Additional Information Request # 6

Hydrogeological Context of Temporary Type 2 Mine Rock Stockpiles

MARATHON PGM-Cu PROJECT

TEMPORARY TYPE 2 MINE ROCK AND ORE STOCKPILE OPTIONS CONSIDERED

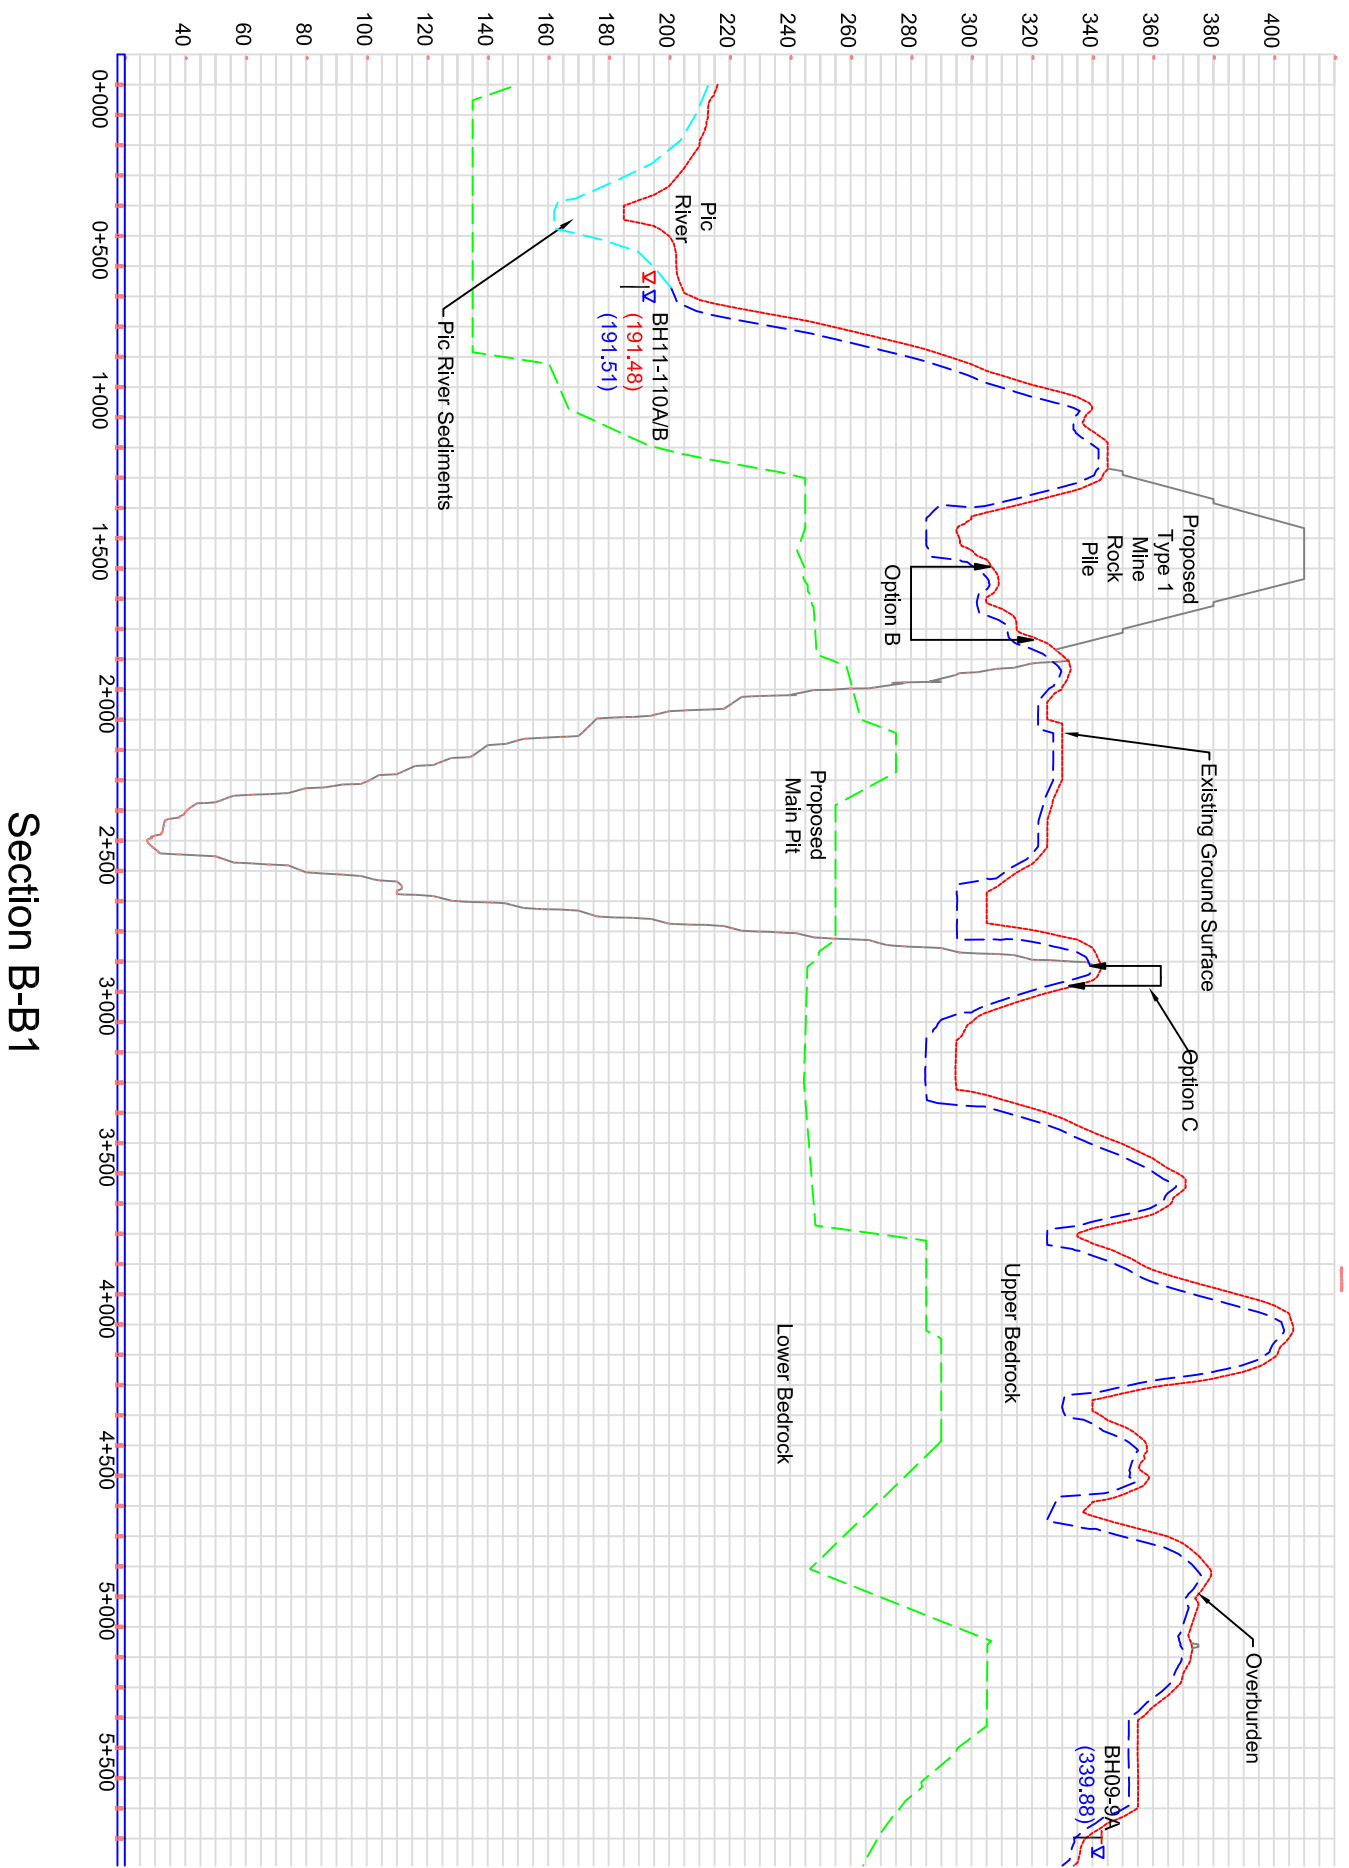
- Provide a map with the locations of the options for temporary PAG (Type 2) storage superimposed on groundwater flow paths. Include the locations of the options for the temporary PAG (Type 2) storage in the cross-sections through the open pit areas.
- Discuss the transport and fate of seepage from these stockpiles in a hydrogeological context, i.e. identify hydrostratigraphic unit(s) through which flow will occur, estimate rate of groundwater flow and travel times to discharge areas and indicate how all seepage will be contained / collected for treatment.
- Explain the implications of the above information on the design and location of the temporary stockpiles.

Figure AIR 6.1 shows the locations of the five options for temporary Type 2 mine rock storage, while Figures AIR 6.2 and 6.3 show updated hydrostratigraphic cross-sections B-B1 and D-D1, respectively. These cross-sections super-impose the locations of Options C and F with respect to the underlying bedrock and the original topography, as well as the open pit. Figures AIR 6-1 through AIR 6-3 also incorporate the topographic contours in the area; the groundwater flow paths associated with each potential storage area are provided below.
